# 1998 - 1999 Corvette: Service Bulletin: Tech - Service Engine Soon (SES) Light Illuminates (Repl Switch Assy)

**Subject:** Tech - Service Engine Soon (SES) Light Illuminates (Repl Switch Assy)

**Number:** 99-07-30-013

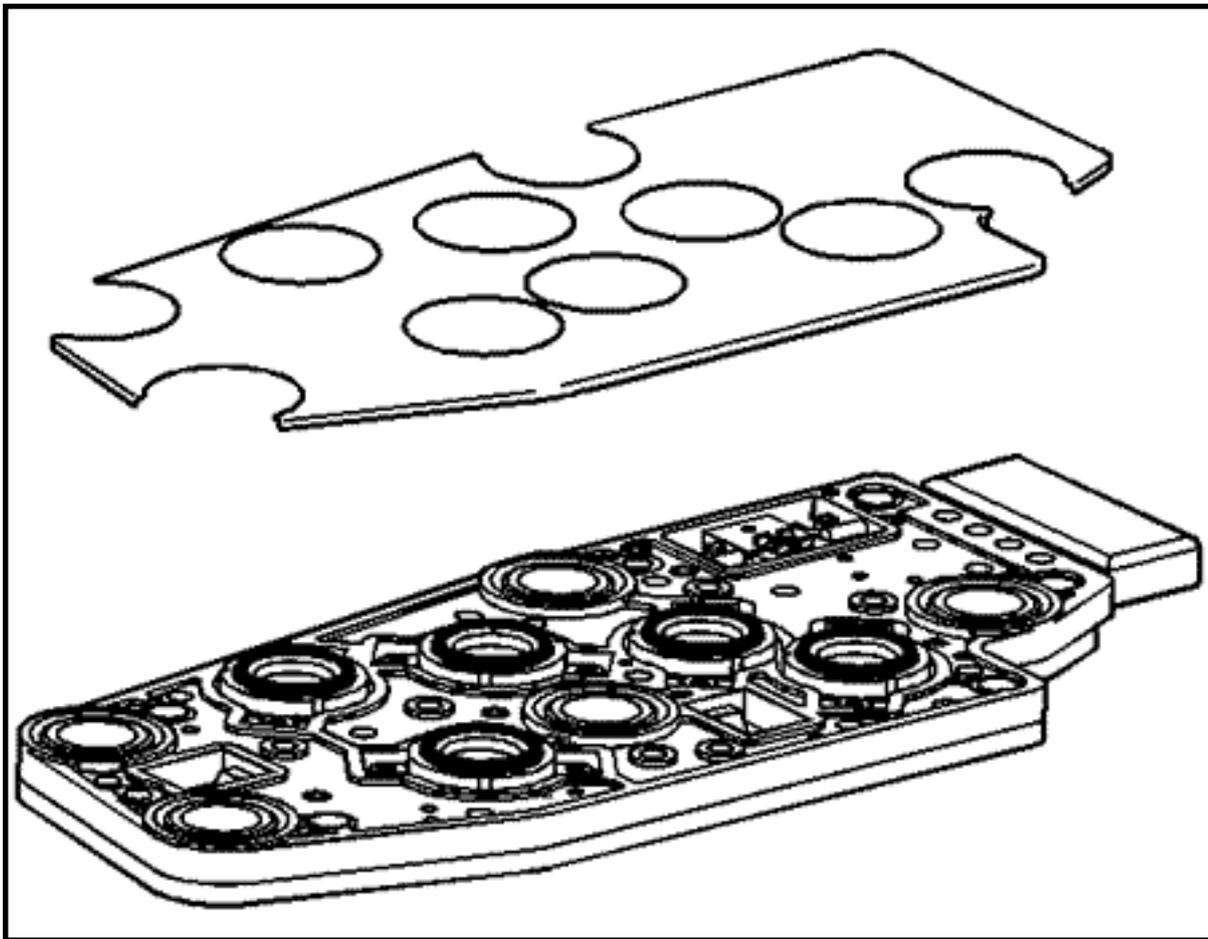
Debris from aluminum shavings, bronze material, and certain clutch material may cause the pressure switches in the TFP switch assembly to stick or electrically short out.

A new TFP switch assembly with a plastic shield has been released. The plastic shield is designed to protect the pressure switch from debris. This improvement will reduce the likelihood of a DTC P1810. This product change went into production on April 8, 1999 (Julian date 098). The existing TFP switch assembly remains relatively unchanged except for the addition of the new shield, creating a new part number for the assembly. The shield fits over the existing TFP switch assembly and is not sold separately.
